**The W Nursing School
Neshoba General
Philadelphia, MS**

Addendum No. 2

June 10, 2026

This addendum forms a part of the contract documents and modifies the original plans and specifications dated June 4, 2026.

A-105

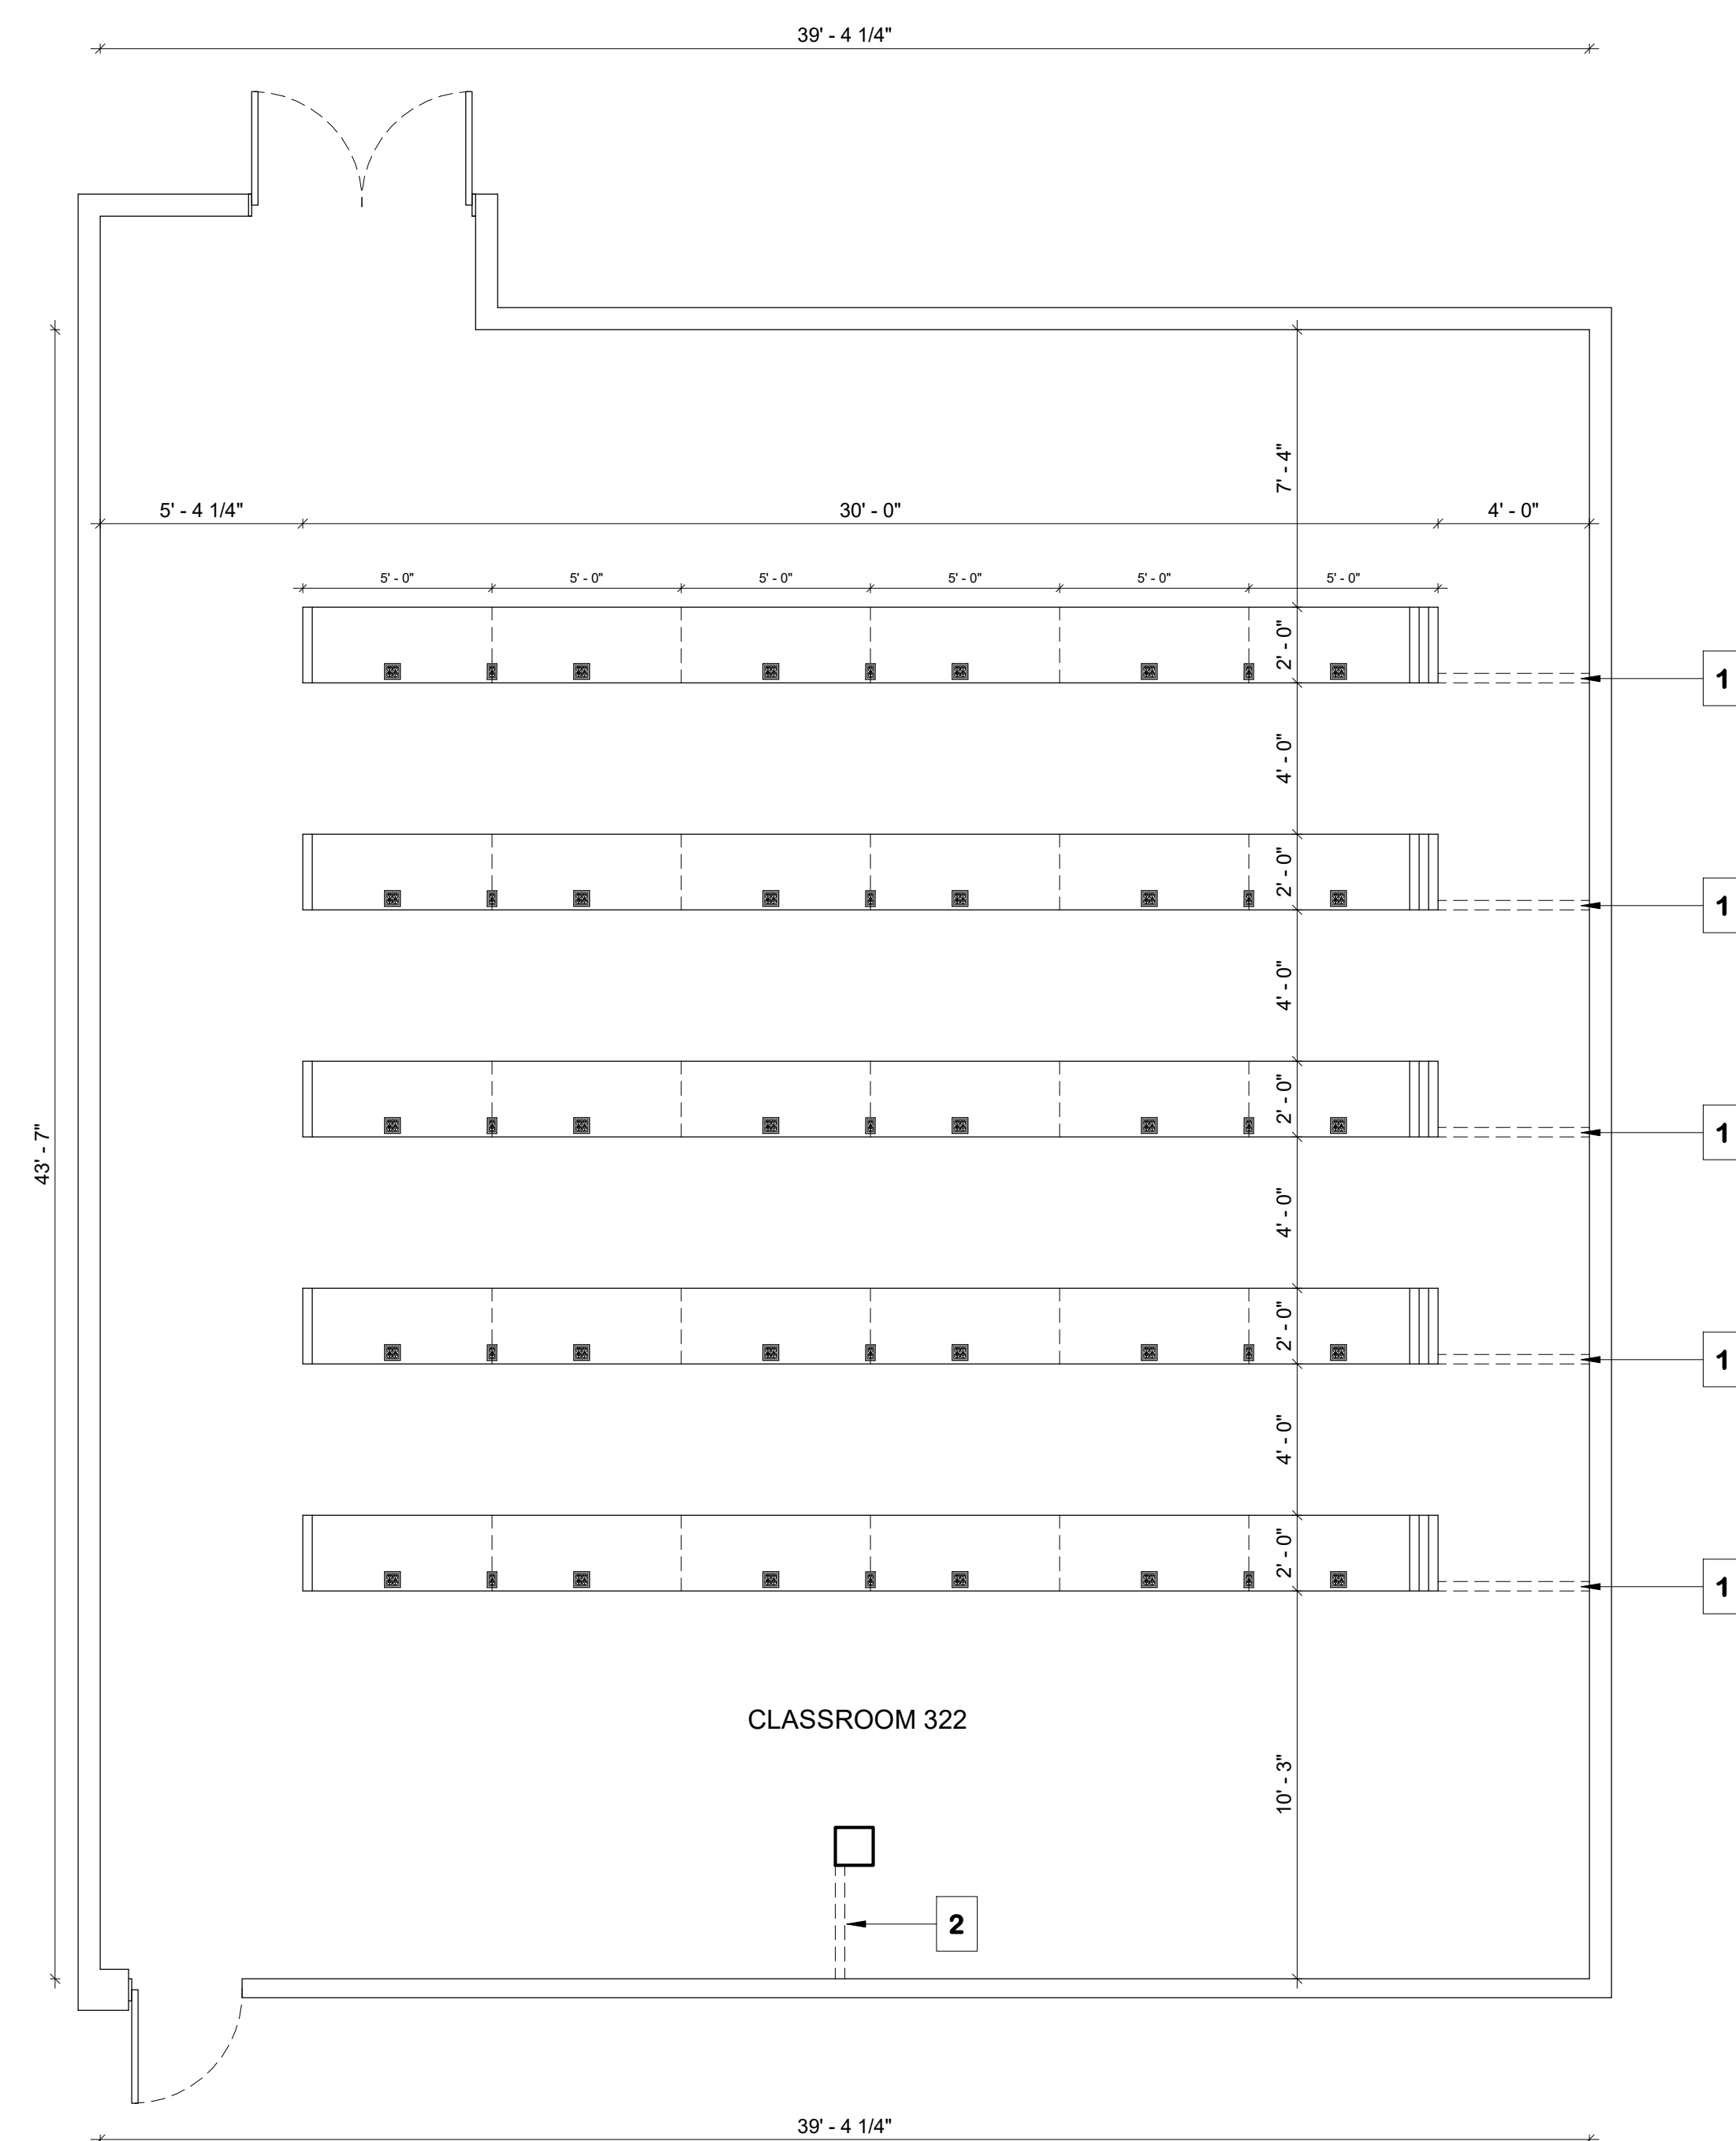
Item 2.4: Sheet A-105

Note: See clouded notes for tube columns to support folding partition beam at 4/A105 and 6/A105. See clouded detail 5/A105 of "lay-in" ceiling to "drywall" ceilings.

sheet no.
A-106
of

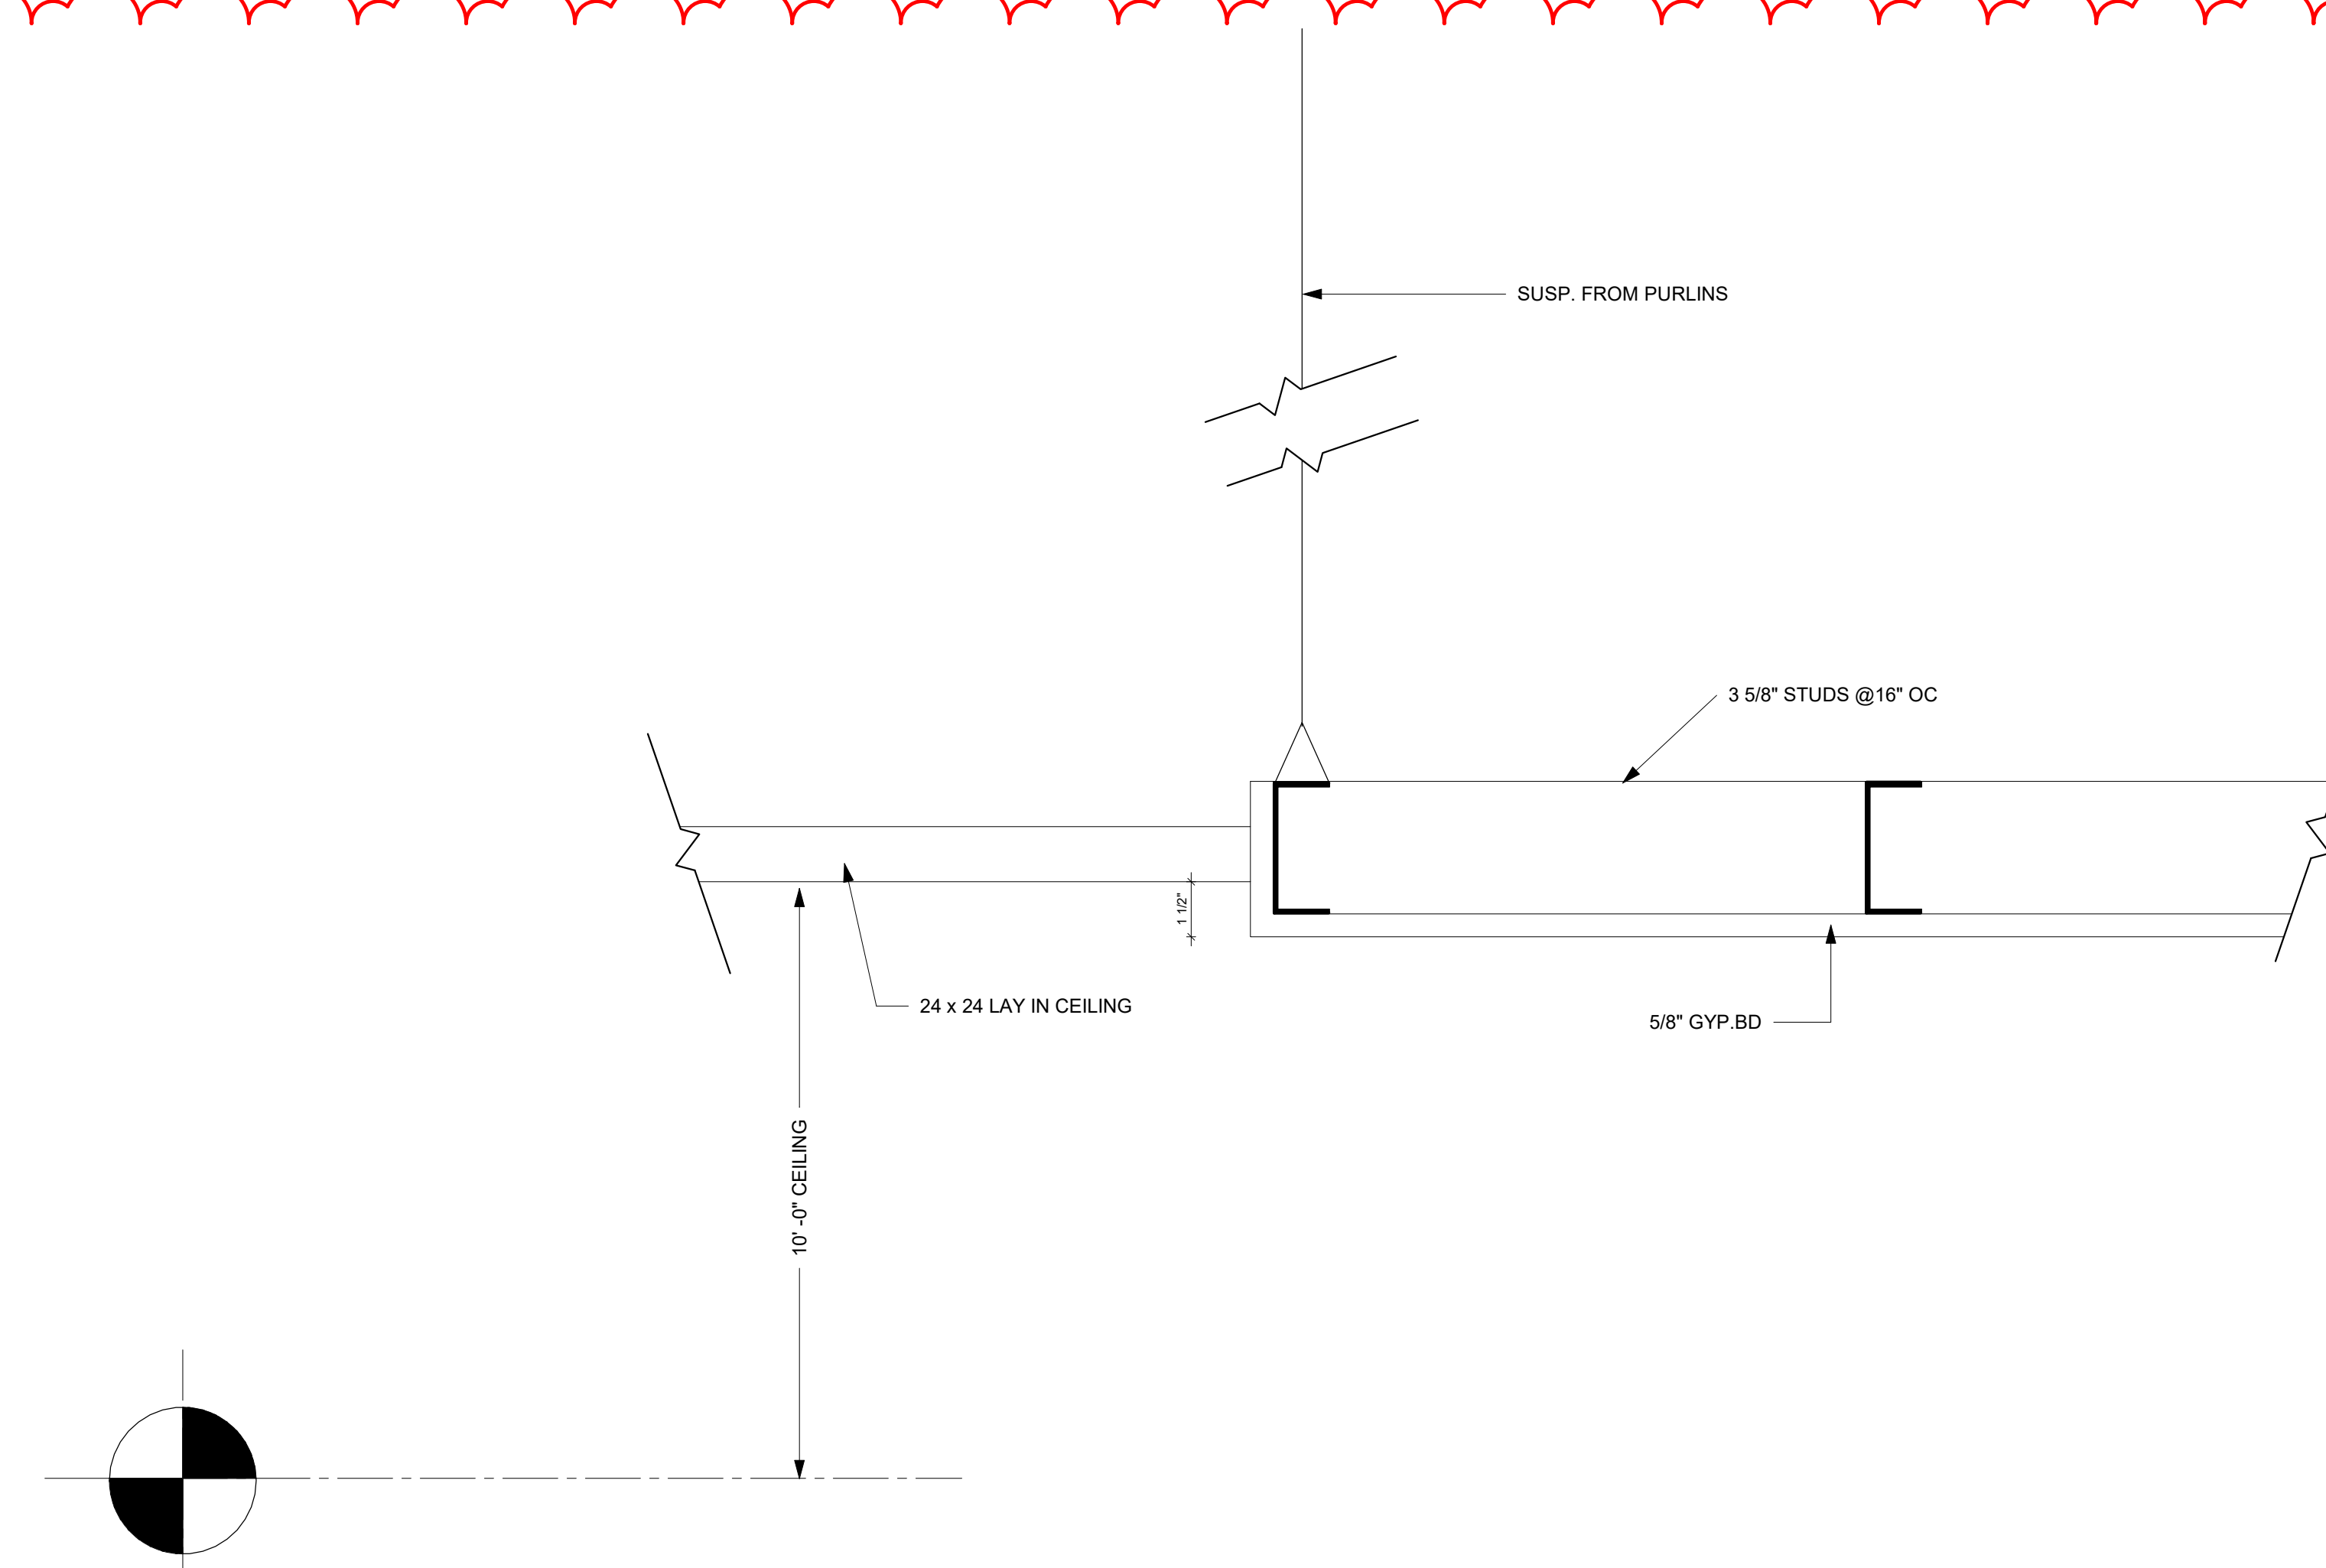
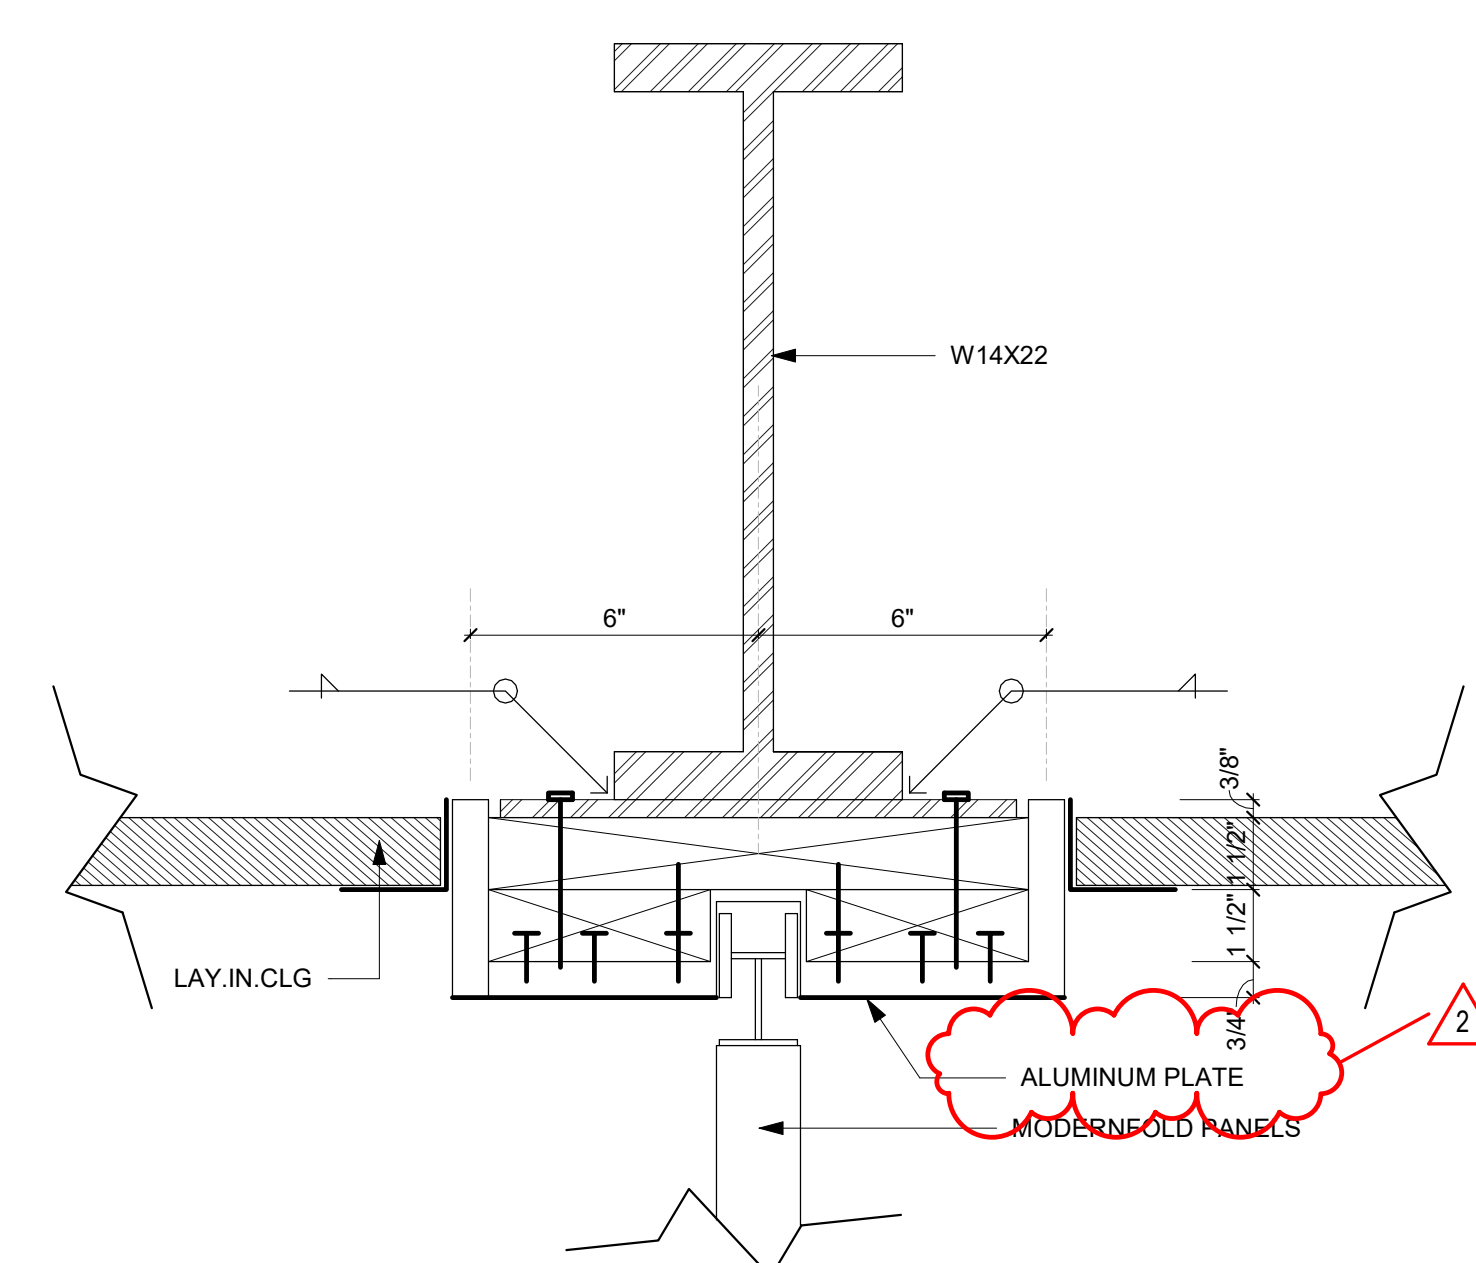
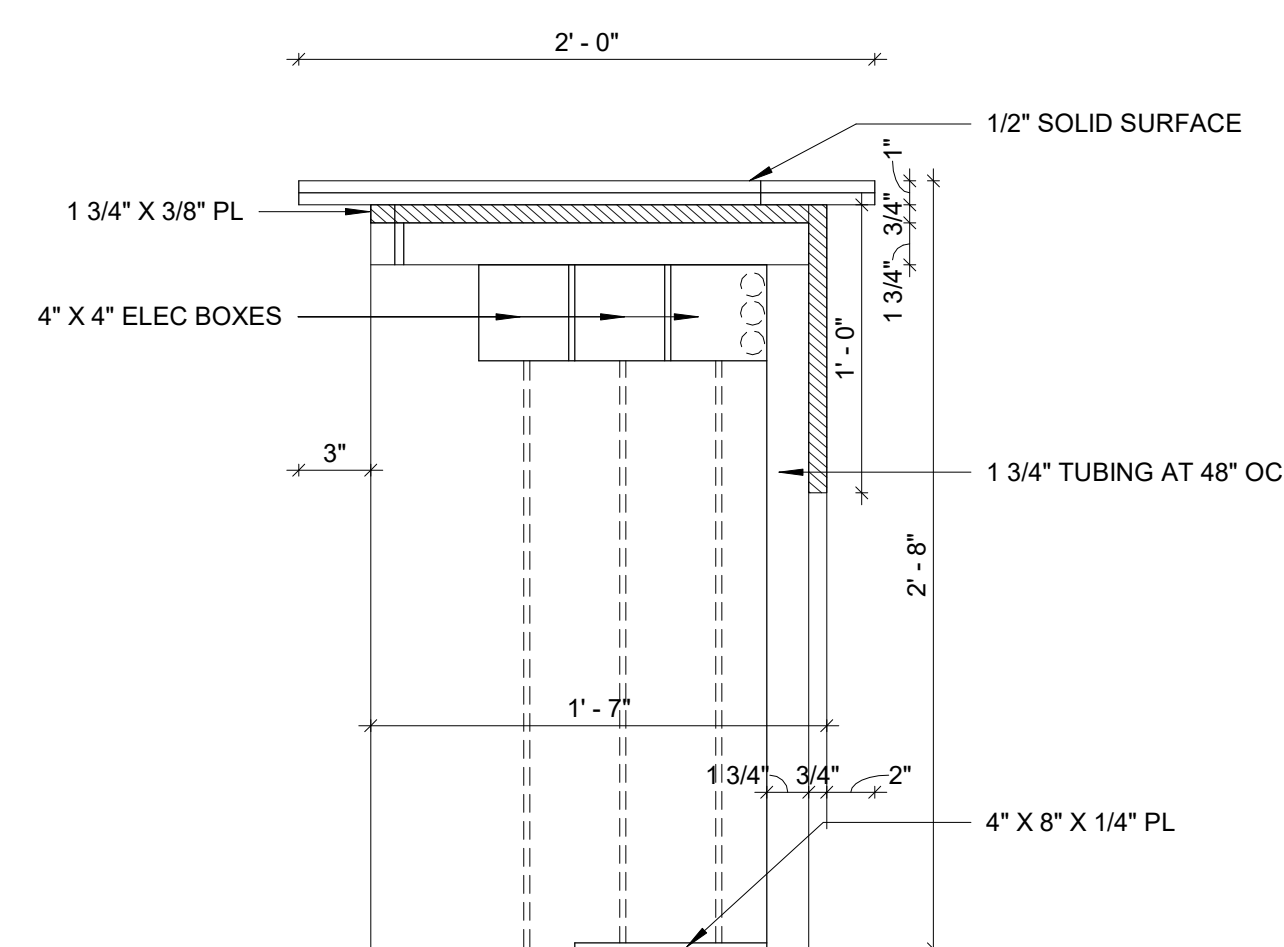
Item 2.5: Sheet A-106

Note: See clouded section references are noted of different ceiling materials.
